### **C.3 CULTURAL RESOURCES CONSULTATION**

Re: Project review under Section 106 of the National Historic Preservation Act of 1966  
Notification of Project and Proposed Phase I Cultural Resources Inventory Scope of Work for the  
W.A. Parish Post-Combustion Carbon Capture and Storage Project in Southeastern Texas (Fort  
Bend, Wharton, and Jackson Counties)

Subject: Response to Texas Historical Commission Request for Backhoe Trenching;  
Proposed Phase I Cultural Resources Inventory Scope of Work for the W.A.  
Parish Post-Combustion CO<sub>2</sub> Capture and Sequestration Project in  
Southeastern Texas (Fort Bend, Wharton, and Jackson Counties)

## Big Creek HDD Entry/ Exit Points

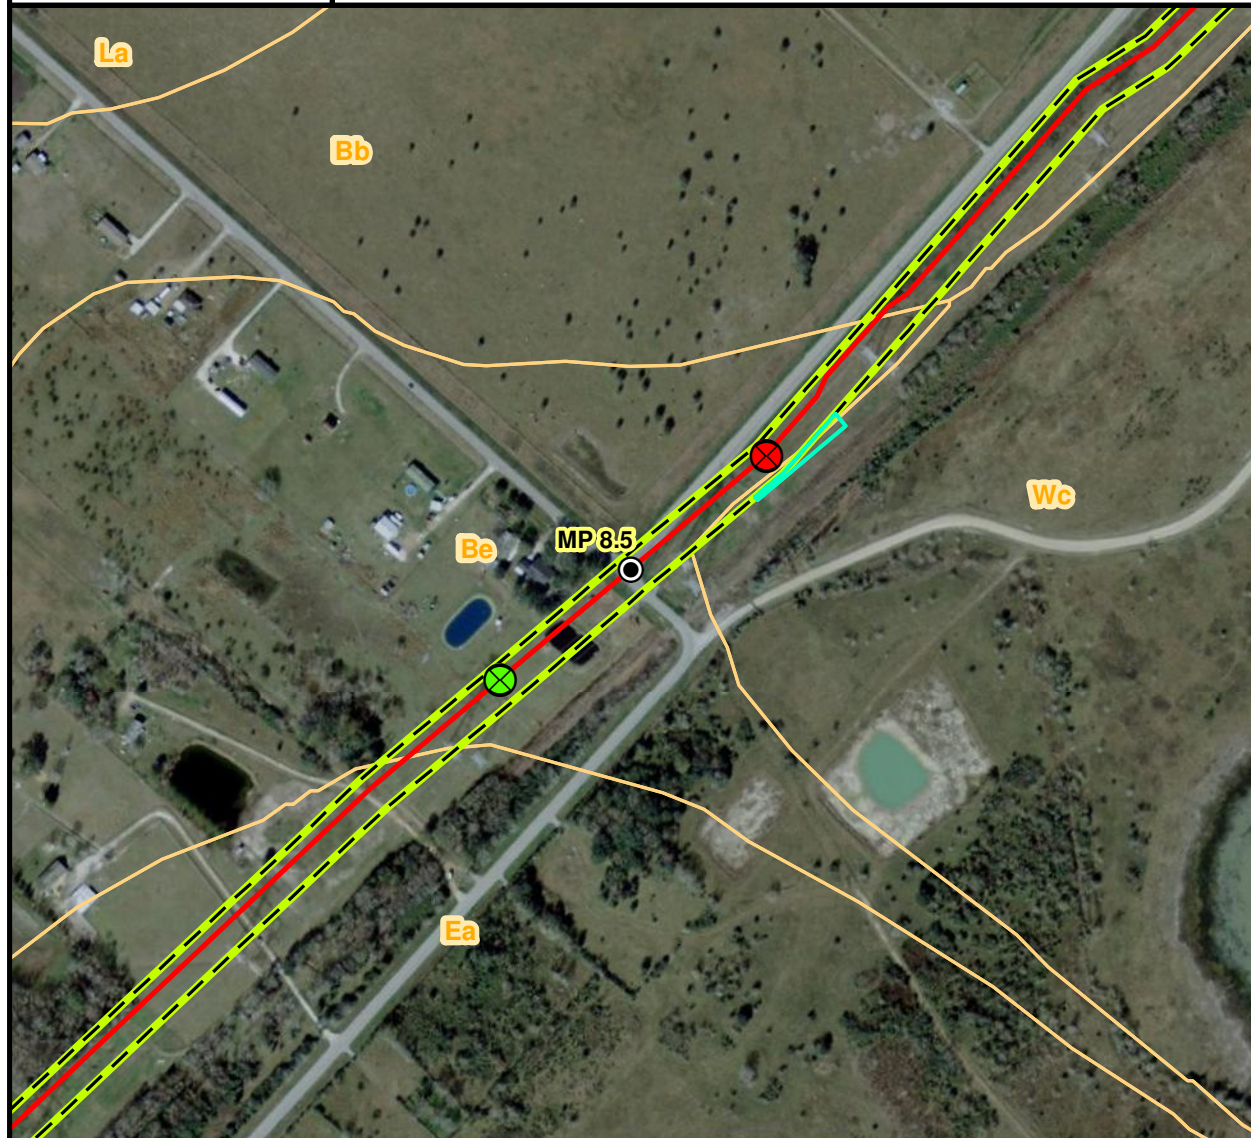
The review staff, led by Jeff Durst, has examined our records. According to our maps, the proposed project area should be surveyed as recommended by URS Group, Inc. (URS). However, we recommend, in addition to the procedures outlined in the URS scope of work, that backhoe trenching be conducted in areas adjacent to waterways where there is the potential for deeply buried cultural resources. In areas where directional drilling will be utilized to pass underneath waterways backhoe trenching should take place at the location of the bore holes entrance and exit points where deep sediments are observed or suspected. In instances where deep sediments are not encountered in these areas then this should be explained in the report as the reason why backhoe trenching was not conducted.

The FM 1994 HDD would cross under a man-made pond and would be completed in Bernard-Edna Complex soil (Table 1), which is associated with an upland landform. Therefore, the U.S. Department of Energy (DOE) proposes that no deep testing would be required for the FM 1994 HDD. Additionally, the HDD exit points for the Big Creek and Lavaca River crossings are characterized by the Edna fine sandy loam and Telferner fine sandy loam, respectively (Table 1). Both of these soils are affiliated with ancient (i.e., pre-Holocene) meander ridges on the Beaumont Formation. Based on their landform characteristics and age, no additional deep testing is considered warranted for the HDD exit locations at the Big Creek and Lavaca River crossings.

The soils encountered at the remaining eight HDD entry and exit locations (i.e., the entry locations for the Big Creek and Lavaca River HDDs and the entry and exit locations for the San Bernard River, Colorado River, and Jones Creek HDDs) are associated with well-defined floodplain deposits that may contain more deeply buried cultural resources. As recommended by THC, DOE proposes that additional deep testing via backhoe trenching be conducted at these eight locations. Table 1 summarizes the recommendations for each HDD entry and exit location.

The deep testing methodology for the eight proposed testing locations would be confined to the approximate boundaries of the proposed entry/exit points. The HDD borehole size is anticipated to be approximately 20 to 24-in (51 to 61-cm) in diameter. During pipeline construction, a pit measuring approximately 10-ft by 10-ft (2.6-m by 2.6-m) in areal extent and approximately 4-ft (1.2-m) in depth would be excavated at each HDD entry and exit point to contain drilling muds. Based on this project design, DOE proposes to excavate a 10-ft-long, 4-ft-deep trench, oriented perpendicular to the pipeline corridor, within the planned entry/exit pit at each of the eight deep testing locations. Trenching would be conducted utilizing a rubber-tired or tracked backhoe, depending upon soil and weather conditions, with a smooth (i.e., clean-up) bucket measuring approximately 3-ft (0.9-m) in width. The trenches would be excavated in approximately 6-in (15-cm) intervals to allow for examination of the exposed trench soils and sidewalls. Any exposed archaeological materials and/or subsurface features would be noted and recorded during this procedure and representative soil profiles would be drawn and photographed for each exposed trench face once the maximum depth of 4-ft (1.2-m) is reached.
